# Board of Health

**TO:** Sherborn Zoning Board of Appeals, ZBA  
**FROM:** Daryl Beardsley, Julie Dreyfus, Mark Oram -- Sherborn Board of Health (BoH)  
**DATE:** November 2, 2024  
**RE:** 34 Brush Hill Homes 40B – Supplemental Percolation Testing

Excerpt from the 9/23/24 Subsurface Sewage Disposal System Plan for Brush Hill Homes (at 34 Brush Hill Road), amended to illustrate concerns regarding percolation rate variability and transition identification.

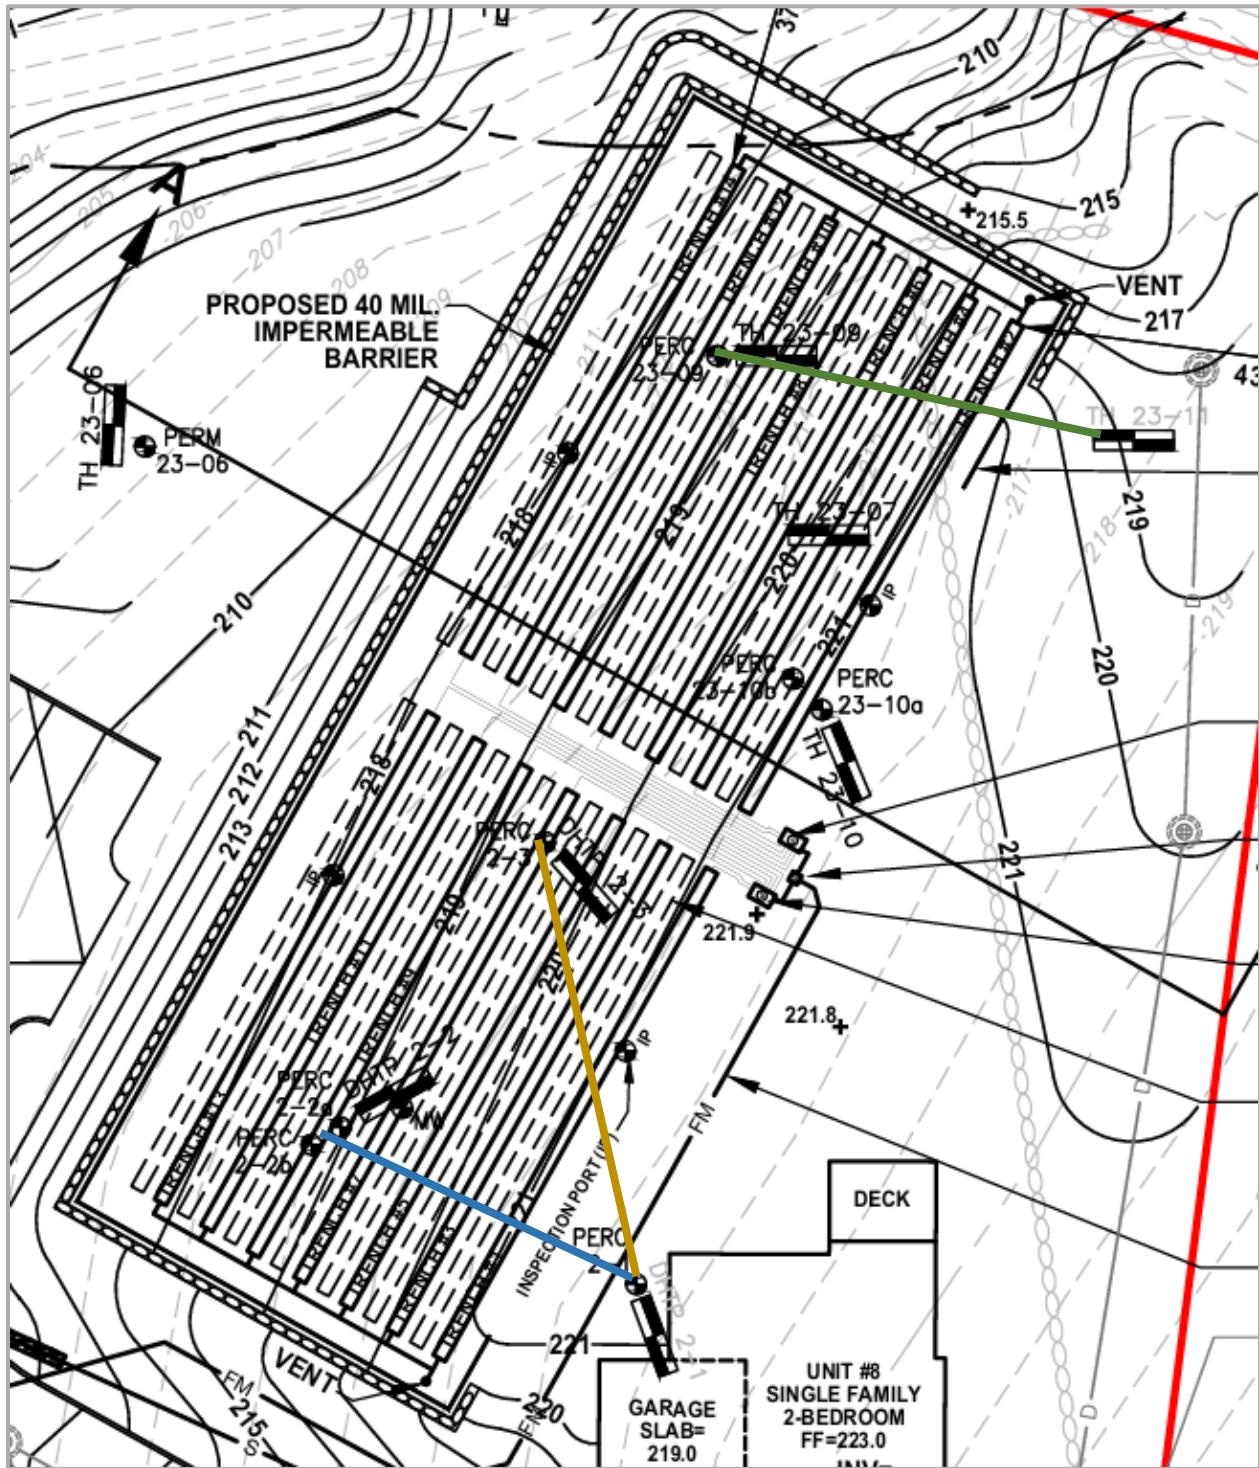
At its meeting of October 16, 2024, the Sherborn BoH voted to require up to 3 additional percolation tests in the vicinity of Trenches 1 and 2 of the 9/23/24 Subsurface Sewage Disposal System Plan for the Brush Hill Homes project at 34 Brush Hill Road. The purpose of this memorandum is to describe the impetus for the additional testing and to provide regulatory sections giving Boards of Health the authority to do so.

The primary reason the BoH is requiring additional testing is the uncertainty about the soil conditions in a significant portion of the proposed large soil absorption system for the property. In the plan excerpt shown on the following page and somewhere along each color-coded transect superimposed on the plan, a transition from a faster to a slower percolation rate is expected.

[a] Transects have been superimposed on the plan excerpt for issue illustration purposes. The percolation tests do not need to be exactly on these transect lines but do need to satisfy the objective of the requirement for additional testing and be in close proximity to Trench 1 or Trench 2.

Percolation rate accuracy is important because it is used to determine appropriate septic system sizing. A reason that 310 CMR 15 (a.k.a. Title 5) subsurface investigation requirements include soil type *and* percolation rate determinations is that soil types are known to exhibit a range of percolation rates depending on localized conditions (e.g., degree of soil compaction and other in situ soil characteristics). In brief, slower percolation rates require a larger system size. Thus, per 15.104(4), the BoH (i.e., Approving Authority) seeks to resolve the uncertainty "where soil conditions vary". Soil types may be similar across this site but percolation rates are not.

(4) *At least one* percolation test shall be performed at every proposed disposal area, one in the primary area in which the soil absorption system is to be located and one in the proposed reserve area. *Additional tests shall be required where soil conditions vary* or as determined by the Approving Authority or where system design exceeds 2,000 gpd. In such instances, a minimum of three percolation tests, spaced uniformly over the proposed soil absorption area, shall be performed in addition to the test in the proposed reserve area.

(5) Where 310 CMR 15.104(4) or the Approving Authority requires multiple percolation tests, the *results of the test providing the slowest rate shall be used for system design*. Averaging of percolation test rates across the site is prohibited.
